2.0 CONTENTS	2
3.0 PROJECT DATA	4
4.0 SITE PLAN	5
5.0 ZONING DATA	6
6.0 DESIGN GUIDELINES	8
7.0 DESIGN REVIEW -EDG	10
8.0 DESIGN REVIEW RESPONSES	
massing	12
entry and streetscape	13
site	14
materials	16
9.0 DEPARTURES REQUEST	18
10.0 ARCHITECTURAL DESIGN	20
building elevations	20
floor plans	24
building section	28
perspective views	29
landscape design	31
11.0 APPENDIX	37

SITE ADDRESS	4401, 4411, 4419 FREMONT AVE N
PARCEL NUMBERS	569350-1505, 569350-1345, 569350-1362, 569350-1375
PROJECT NUMBER	3039251-EG, 3039107-LU

ARCHITECT	Atelier Drome Architecture 119 S. Main St. Suite 310 Seattle, WA 98104
CONTACT	Michelle Linden michelle@atelierdrome.com

EDG BOARD RECOMMENDATION

enlarged plan

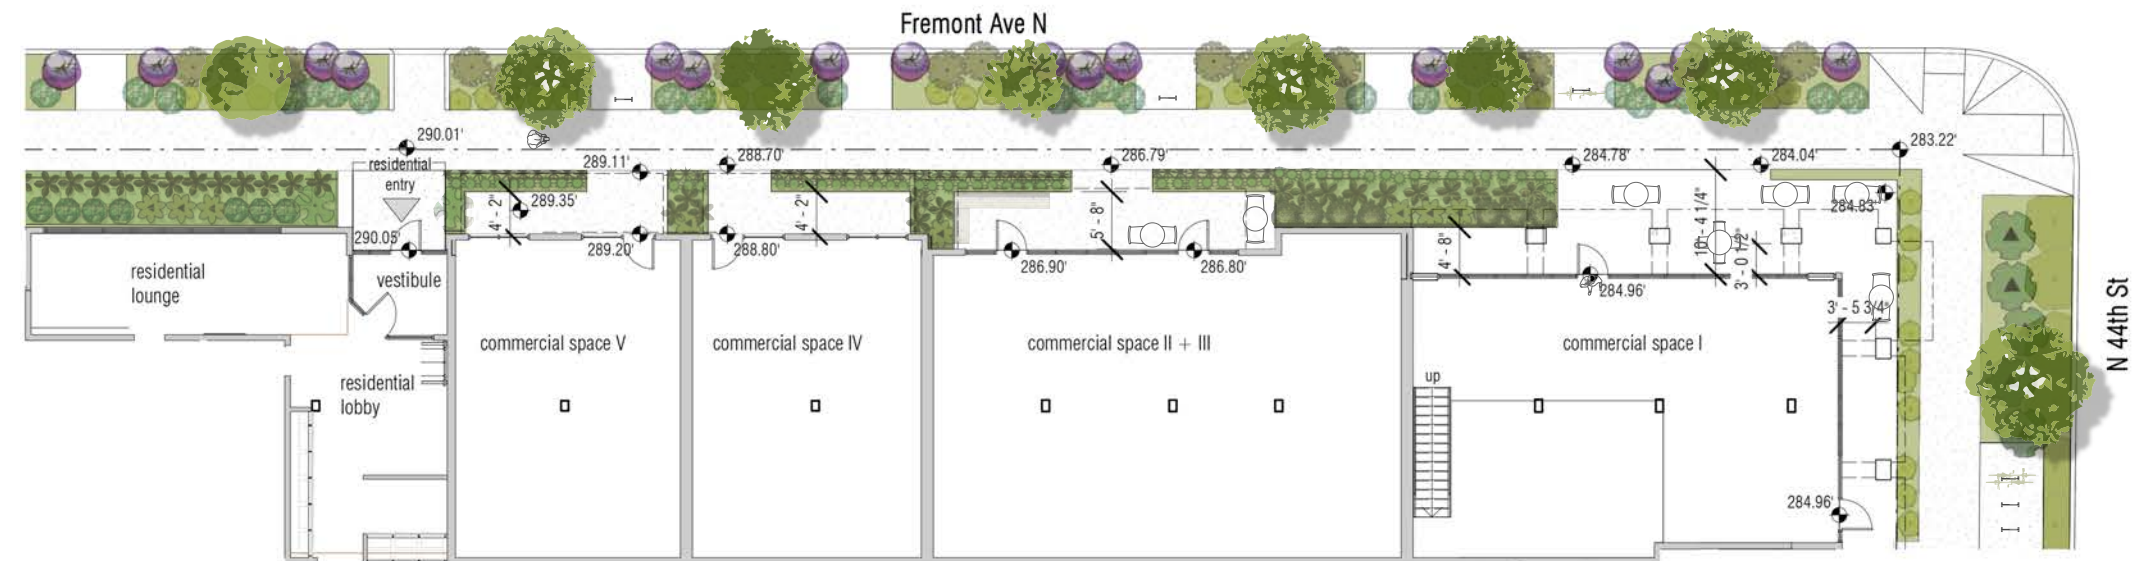
The Board agreed that the Option 3 building massing created the best opportunities for development of appropriate and relevant site plan.

The Board supported the inclusion of streetscape amenities, like the benches shown at the sidewalk edge on the landscape plan on page 44 of the EDG packet, that create opportunities for engagement and activation at the property line.

The Board supported the 'jogs' shown in the site plan along the street frontage at the commercial unit entries. They supported the concept of retaining the grade between the commercial entrances, creating unique entrance areas. They noted that this layout gave scale to the site design and helped to create a 'small shop' feel to the commercial units.

The Board generally supported the establishment of wider planting strips and new street trees along both street frontages, as required by SDOT. The Board suggested including logical breaks in the planting strips for access to/from street parking.

The Board also noted the high pedestrian use of the public realm in this commercial area and suggested a selection of sturdy plantings that will withstand the high use and high visibility of this location as the project landscape design moves forward.

Benches directly adjacent to the sidewalk have been provided adjacent to the residential entry with additional benches, bike parking, and planters within the patio spaces in front of each commercial entrance. These unique spaces provide usable exterior areas for each commercial unit while still providing an active and engaged pedestrian experience. The individual patios also help contribute to the pedestrian scale of the structure. Breaks in the planting strips provide easy access from parking to the commercial spaces as well as short term bike parking.

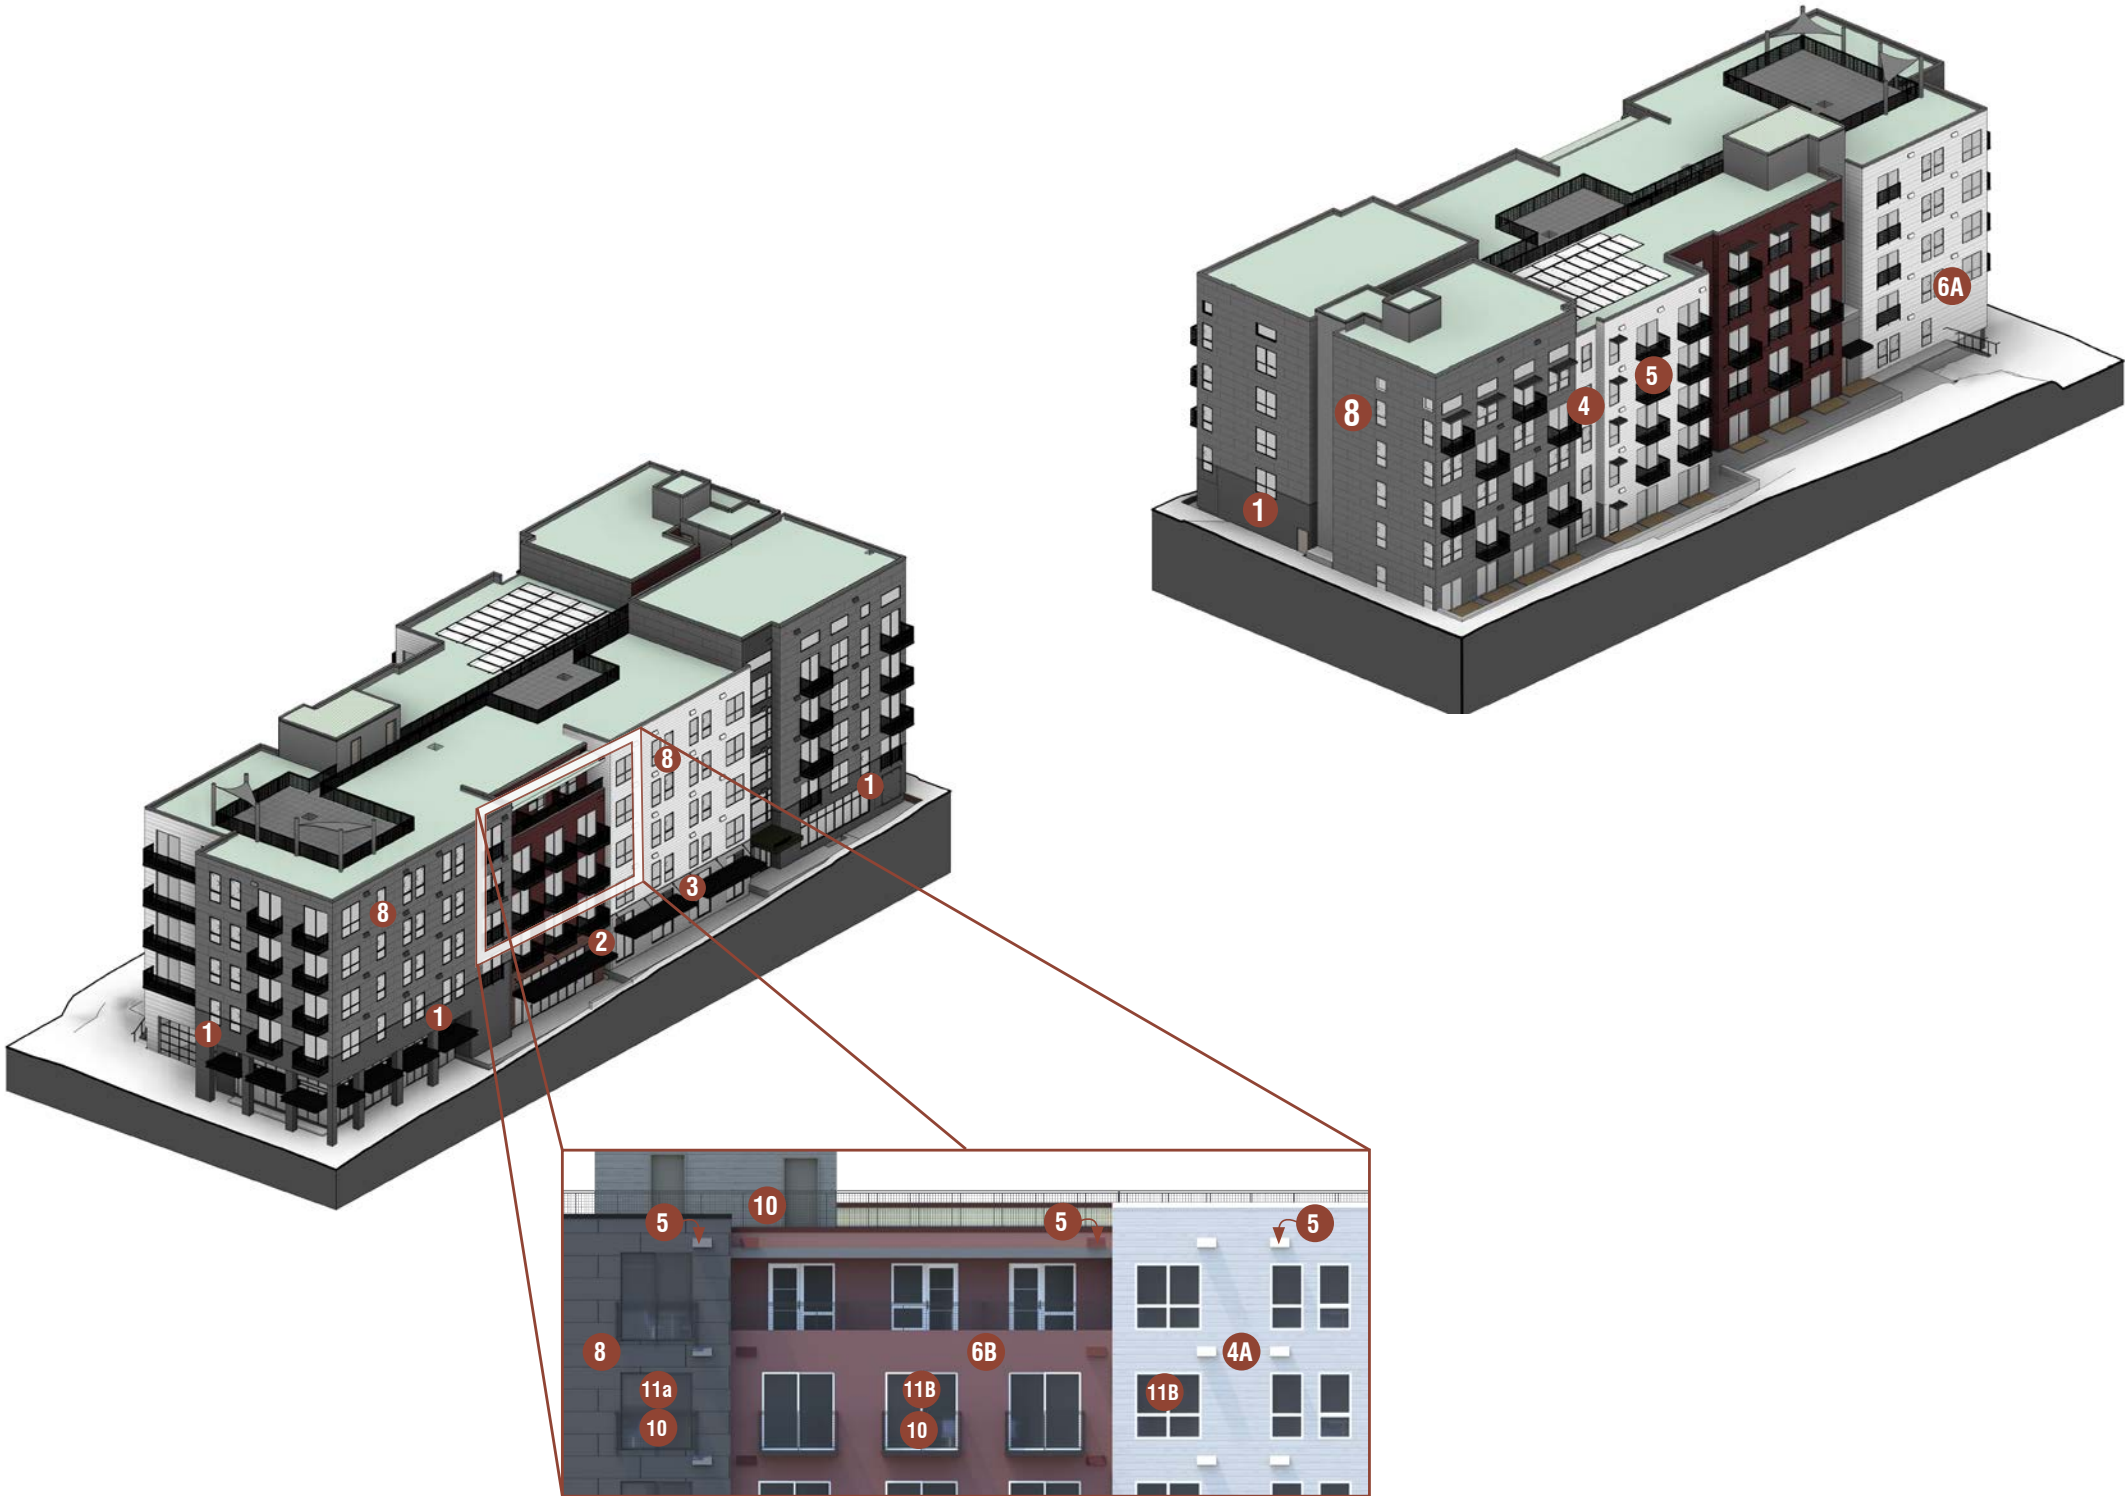
The Board supported the concept of material application presented in the architectural precedent images associated with Option 3, as shown on page 35 of the EDG packet. The applicant noted that they did not have a specific materials palette in mind but will be developing that now that a specific massing option has been chosen. The Board suggested limiting the materials palette so the façade composition does not become overly complicated. The Board commented that a restrained materials palette could aid the project in relating to the surrounding small-scale context. One Board member suggested that the applicant could tie materials shown in the neighborhood historic context presented in the packet into a contemporary interpretation with a 5-story building.

The Board noted the high degree of visibility of all four facades of the building due to the height of the new structure. The Board emphasized the importance of continuing the material concept from the two street-facing facades to the rear of the building where the zone transitions to lower density uses.

The material expression for the project reinforces the vertical modulation and façade composition. Each vertical mass is conceived as a unified form from top to bottom. At the commercial pedestrian frontage, smaller scale bricks are utilized to respond to the human scale and nod to the historic precedent in the neighborhood. Above the bricks, cementitious panels or planks are painted in a similar tone to the brick below in order to contribute to the cohesion of the vertical masses, while offering a residentially scaled material. Three neutral colors are provided – dark grey, white, and brick tone with windows shown in a coordinating finish of either black or white. The vertical expression of the material concepts extend along all four sides, with the brick fronting the pedestrian experience only.
